CALIFORNIA COASTAL COMMISSION

Staff Report: 6/11/97

STAFF REPORT: PERMIT AMENDMENT**APPLICATION NO.:** 4-95-101A**APPLICANT:** Steve and Leslie Carlson**AGENT:** Land and Water Company**PROJECT LOCATION:** 100 South Topanga Canyon Boulevard, Topanga, Los Angeles County**DESCRIPTION OF PROJECT PREVIOUSLY APPROVED:** Construction of three new commercial structures on a lot containing existing commercial development. New construction is to include a 1,840 sq. ft. single story restaurant, a 9,200 sq. ft., 35 ft. high above existing grade retail structure, a 10,970 sq. ft., 35 ft. high above existing grade retail structure, 48 parking spaces, demolition of a small shack and minor storage lockers, and installation of a new septic system, with no grading on a 82,000 sq. ft. lot.**DESCRIPTION OF AMENDMENT:** Consolidation of proposed project into two buildings containing 20,570 sq. ft. of office and retail uses (reduction of total square footage by 1,440 sq. ft.). The height of both buildings will be reduced to 25 ft. from existing grade. Building A is 11,060 sq. ft., and Building B is 8,960 sq. ft. in size. The approved restaurant use will be deleted from the project. Total on-site park

ENCLOSURE #1

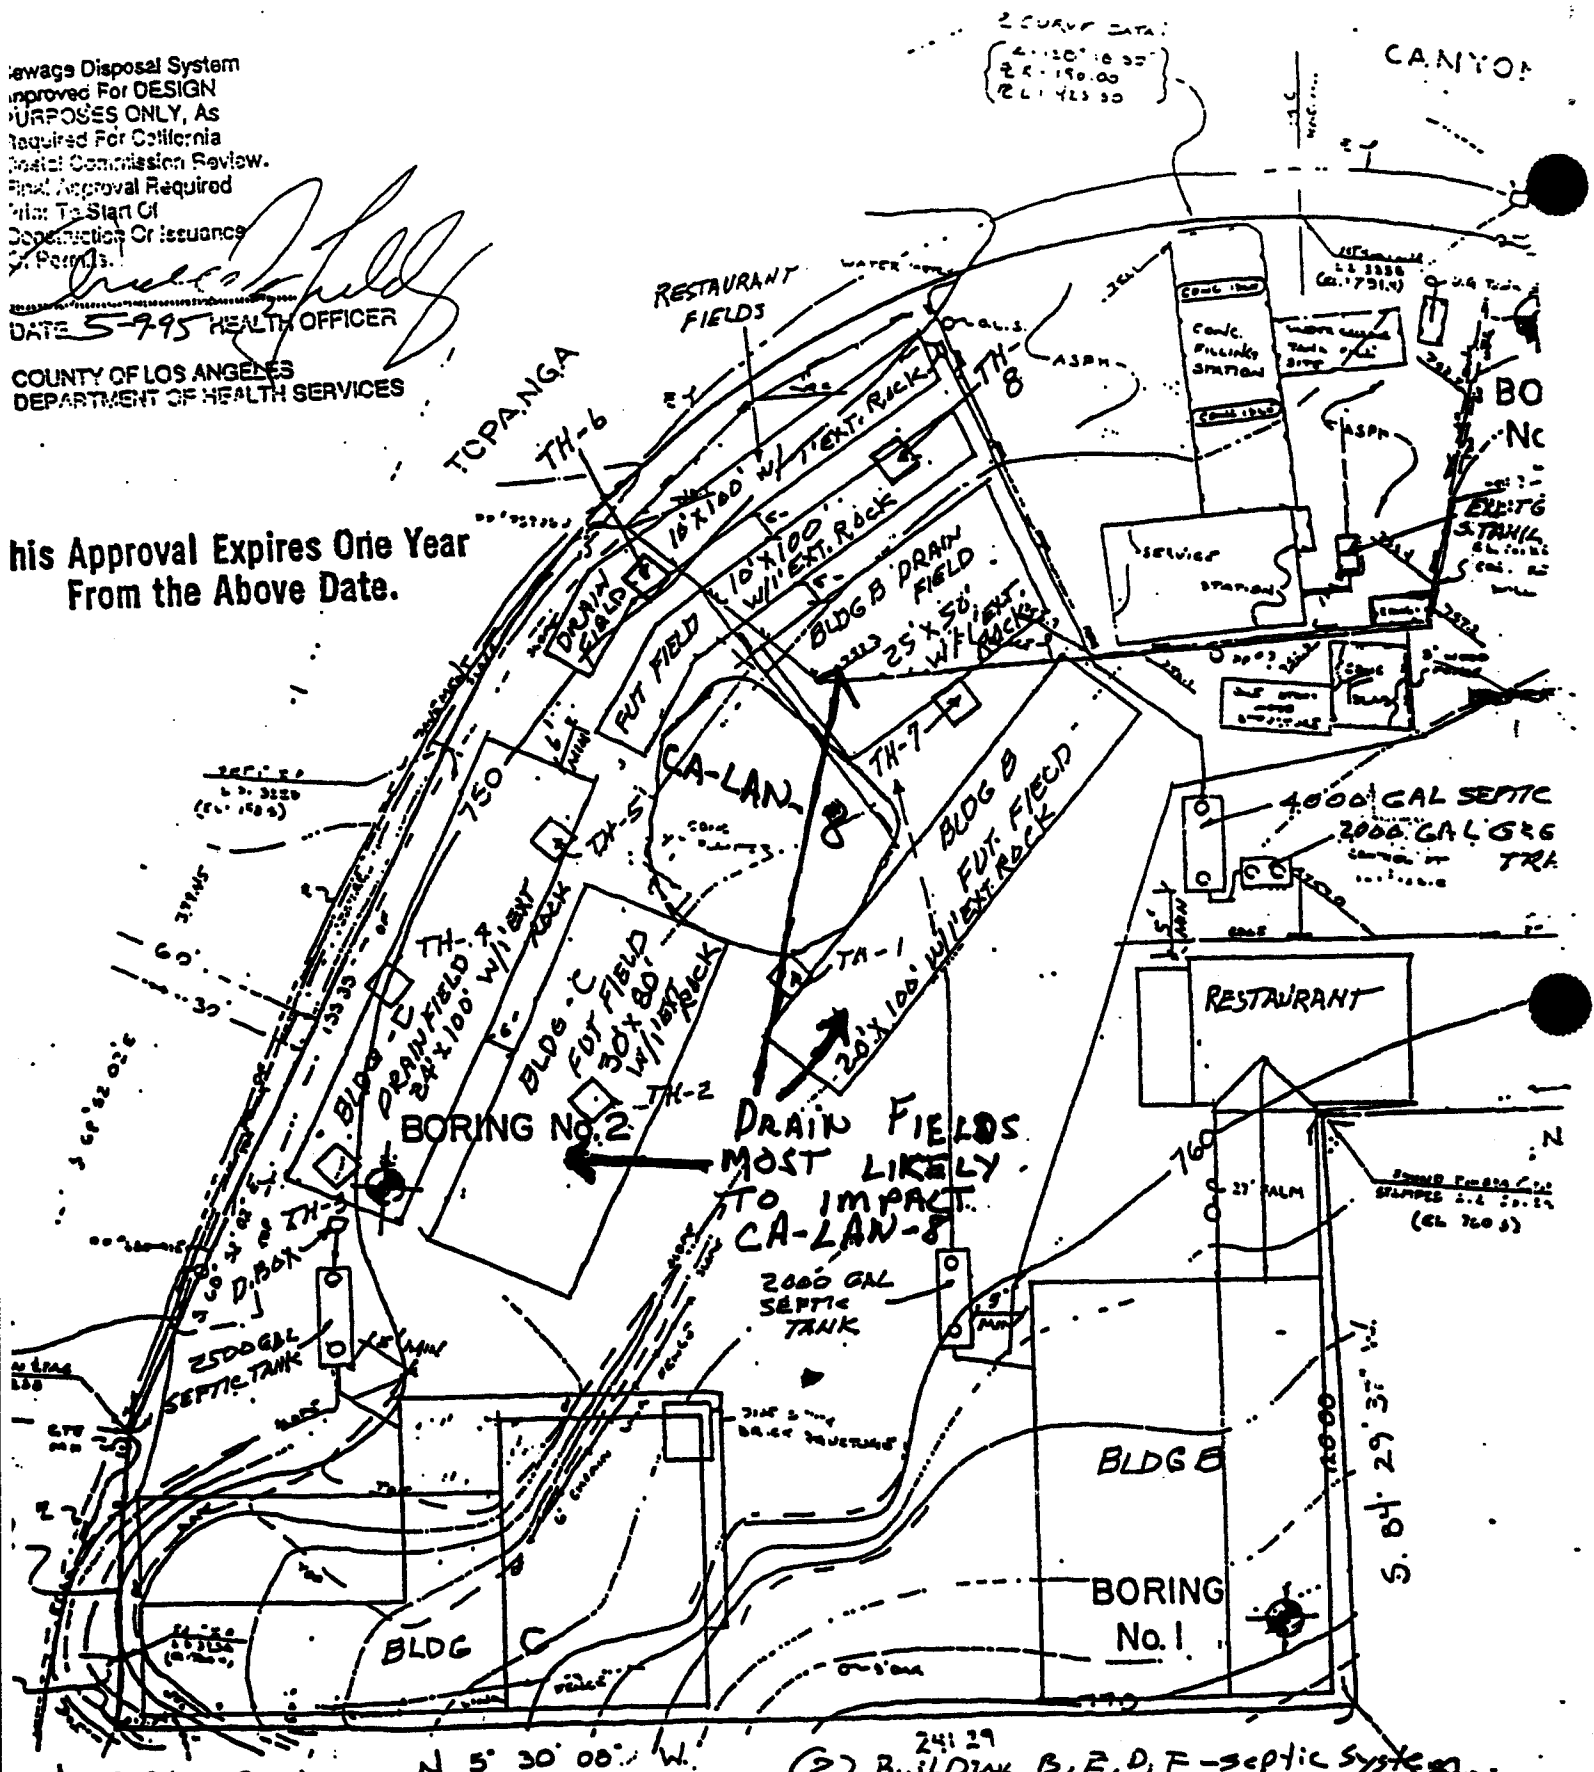
Based on the "Sewage Disposal System" map of 5-9-95, in my opinion as an archaeologist, CA-LAN-8 may well be significantly effected by the project. Inspection of the map (Enclosure 1) reveals that the site is surrounded by drain fields. Oversaturation of the drain fields over time could well result in contamination of the archaeological site by the brackish water. The increased dampness of the site soil, stemming from the surrounding saturated soils, plus possible chemical constituents contained in the brackish water could quite easily lead to an increase in the disintegration of bone and shell in CA-LAN-8. According to the report, these items are already sparse in the intact deposit.

First, additional controlled archaeological work must be undertaken prior to construction to more closely determine the exact boundary of the intact deposit as well as to establish a sufficient "buffer" zone around the intact area. Parts of three of the six proposed drain fields are almost touching the estimated area of the intact midden (Enclosure 1). These three are the most likely to contaminate CA-LAN-8 as they are on the same slope level or up-slope from the intact deposit.

However, the areas of all of the drain fields closest to the intact midden should be hand-excavated down to the colluvial layer, while being monitored by archaeologists and Native Americans once construction begins. If any intact deposit is encountered, work must be stopped in those areas while excavation plans are made and implemented.

To prevent contamination of the intact midden, some sort of detention or containment system must be devised to keep the brackish water from reaching any part of the intact deposit. The containment system should be developed in consultation between soils engineers, geologists, construction engineers, and archaeologists. The final approval, however, would rest with the Coastal Commission. This containment system should also be placed on the side of the drain fields facing Topanga Canyon Boulevard to prevent the brackish water from entering the road fill layer and softening the roadbed. Unfortunately, the final placement of the drain fields is quite restricted since water percolation is so poor in the project area. Even Mr. Carlson himself, mentioned this fact at the September 28, 1995 town meeting here in Topanga.

In response to the above stated concern, the following is relevant. The area that was excavated by Singer and Associates in 1994 and the area that was covered by our recent excavations (ERA) in 1997, have been mitigated in terms of the cultural resources present there. This position was attested to by both the Singer 1994 report and by our own (1997). As part of that mitigation, it was recommended by the Singer report and by our own report that the area of intact midden (Area 1) as defined by Singer in 1994, be mitigated via preservation. Mr. Steve Carlson, the owner/developer, has agreed to this commendable mitigation measure.

Regarding whether leach lines (and their attendant leach fields) would adversely impact or affect the cultural deposit, the following is relevant. The percolation layer (sand/gravel alluvial geological deposit) varies from - 5' to 7' across the area in question (i.e. on and surrounding the intact prehistoric midden area; see "Area 1" on Figure 3 in the ERA 1997 report). The present extent of the two adjacent leach fields is as follows. The leach field on the SW side comes no closer than 20' to Area 1. The leach lines would be implaced at depths of 4.5 and 5', that is below the depth of the maximum depth of the cultural deposit in that area (i.e. Singer went down to a maximum depth of cultural deposit of 80-90 cm or less than 3 feet). Similarly, the other leach field, located on the ESE side of Area 1 comes no closer than 15' of Area 1's perimeter. Its leach line pipes will be implaced to a depth of 4' (again below the cultural layer depth). Both leach fields are downslope from Area 1. Thus there is little probability that effluent from the two leach fields will percolate horizontally over distances of 15-20' especially when the fields are downslope and the leach lines are below the depths of the maximum depth of the cultural deposit. Thus it is highly unlikely that the leach fields will impact the cultural deposit of Area 1 (the intact prehistoric midden of site CA-LAN-8/H that will be preserved in perpetuity).
